Ulan Coal Mine Mod 4 Submission (addition to presentation 19 June 2019)

Julia Imrie BSc. Grad Dip Water resources, PhD Candidate (Fenner School) ANU

Figure 1 (SLIDE 19 PPT): Piper diagram showing the groundwater Hydrochemistry (% meq/L) from The Drip and the North Monitoring Network (NMN) collected by UCML

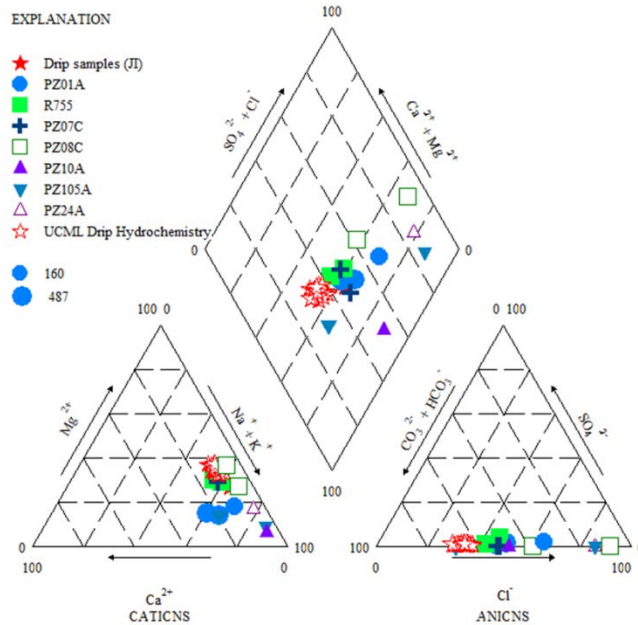
The character of groundwater discharging at The Drip indicate a dominance of bicarbonate, sodium and magnesium ions, type Na (Mg), HCO₃, a slightly alkaline pH ~ 8 and a relatively low EC in the range 380-580 µS/cm. Calcium levels are similar to some of the NMN Triassic bores. Monitoring results of the groundwater type found at R755, PZ07C and PZ01A (NMN) exhibit similar characteristics to The Drip seep (see Table 1, Figure 1). This could be interpreted as the result of a mixing of Triassic groundwater with basalt groundwater associated with the extensive Tertiary basalt geology intrusions that lie about a kilometre to the north of The Drip. The longer the groundwater flow path and residency time the greater contact and interaction with geological strata and opportunity for ion exchange and mineralisation (Fetter, 2001; Freeze and Cherry, 1979). Alternatively fresh rainfall recharged Triassic springs fed from very local sources exhibit Na, Cl type water. These are located more often at higher elevations closer to the Great Dividing Range (Munghorn Gap and Wollar).

The diversion and interception of groundwater flow away from The Drip and Goulburn River threatens the long term viability and resilience of this highly valued groundwater dependent feature. Once impacts become obvious it will be too late to prevent permanent irreversible damage. The precautionary principle states if there are threats of serious or irreversible environmental damage, lack of full scientific certainty should not be used as a reason for postponing measures to prevent environmental degradation. This principle is relevant when considering the risk from increased depressurisation and interference to the groundwater system and need to ensure the long term protection of groundwater sources feeding The Drip GDE and river base flow.

Figure 2 – Flow curve for stream discharge showing persistent flows recorded at Ulan (210046) but not at Coggan (210006) or Sandy Hollow (210031) between 1968 and 1982 (pre-mining expansion at Ulan)

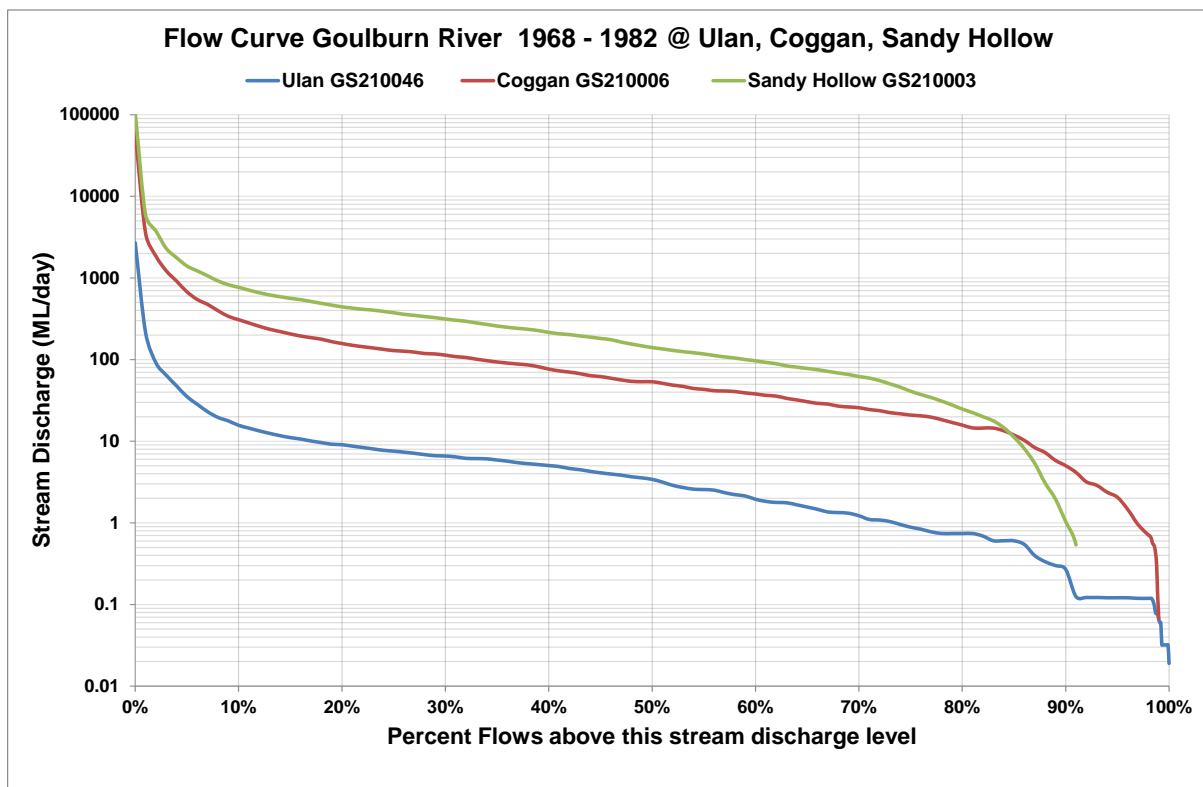
The loss of natural low flows from groundwater inputs has meant the river is now reliant on mine water discharges. The proxy regulation of river flow can be seen by the close correlation between stream flow and mine water discharge at the Ulan DS gauge (SW02) both in 2014 (SLIDE 11 PPT) and more recently. When mine discharge ceased in late 2017, early 2018 the river stopped flowing and water levels in the river bed dropped below the sand to unprecedented levels. Conversely stream flow data 1968 -1982 at Ulan GS 210046 pre-mine (Figure 2) show persistent flow in the upper Goulburn at Ulan (GS210046). This includes one of the worst recorded periods of drought in the early 1980s (1980 = 449.7 mm) (NSW-Department-Water-Resources, 1994).

Figure 3 Percentile distribution of daily specific salt load at three gauging sites on the Goulburn River for the period 2012-2016.

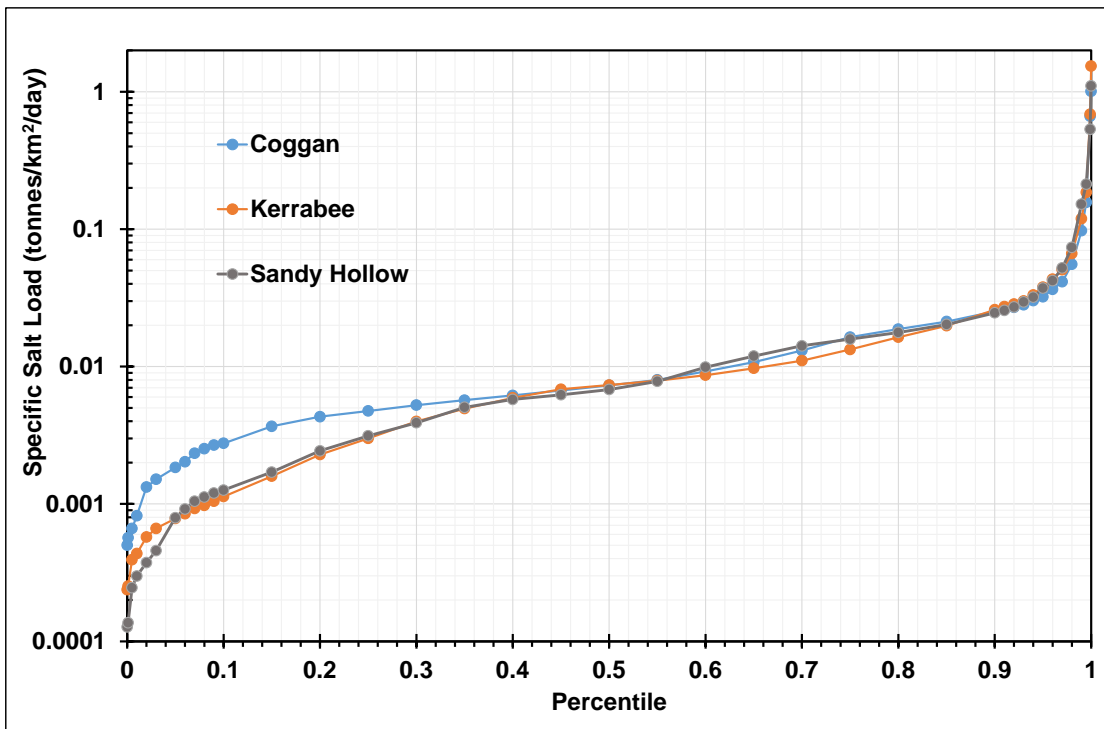
Figure 3 plots the percentile distributions of daily SL/A for the three gauging sites for the period 2012-16. Coggan has a notably higher specific salt load than the other two stations below

percentile 0.4. The higher geometric mean SL/A for Coggan in Table 2 reflects the higher SL/A values below percentile 0.4 at Coggan gauge which is an indication of either mine water discharges or increased groundwater discharge. The magnitude of this extra salinity source can be estimated if it is assumed that the geometric mean daily specific salt load at Sandy Hollow and Kerrabee is the natural salt load at Coggan (0.0065 tonnes/km²/day). If so the geometric mean daily salt load would be 21.7 tonnes/day. The actual geometric mean specific salt load at Coggan is 27.4 tonnes/day (0.0082 tonnes/km²/day). This suggests an additional source of salt in the upper catchment of 5.7 tonnes/day, or 2,080 tonnes/year. The tonnage of salt exported by UCML in mine discharge water averaged 2,758 tonnes/year in 2012-20166 (12,871 tonnes over 4.7 years). In 2017 UCML discharged 5,606 ML of mine water into the Goulburn. At an average EC 800µS/cm this equates to over 3,000 tonnes of salt or 8.2 tonnes salt /day (UCML, 2017).

In summary any approval of Mod 4 should be dependent on significant improvements to surface water and groundwater management. This includes;

- Lowering EC of discharge water to background levels 500 µS/cm
